LOT 33 (Re-site)

SITING AND GRADING PLAN

Plan No. 33  
Street Name DEERHAVEN CRESCENT

GOLDPARK HOMES - 217020  
PINE VALLEY, VAUGHAN ONT.

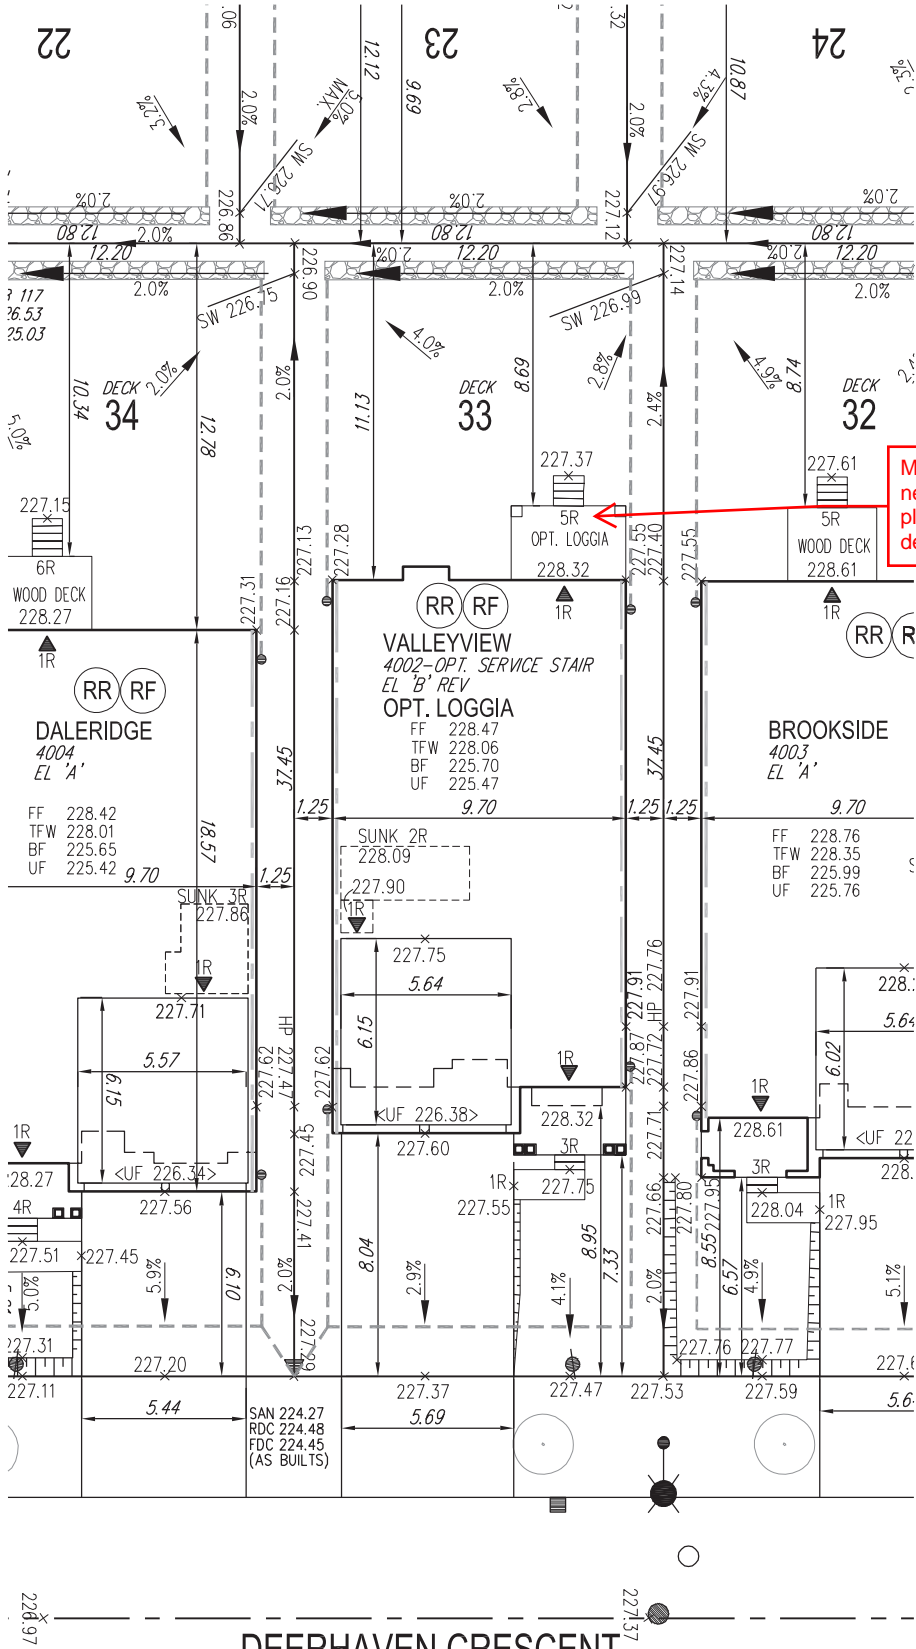
Min 4" gravel need to be placed under deck
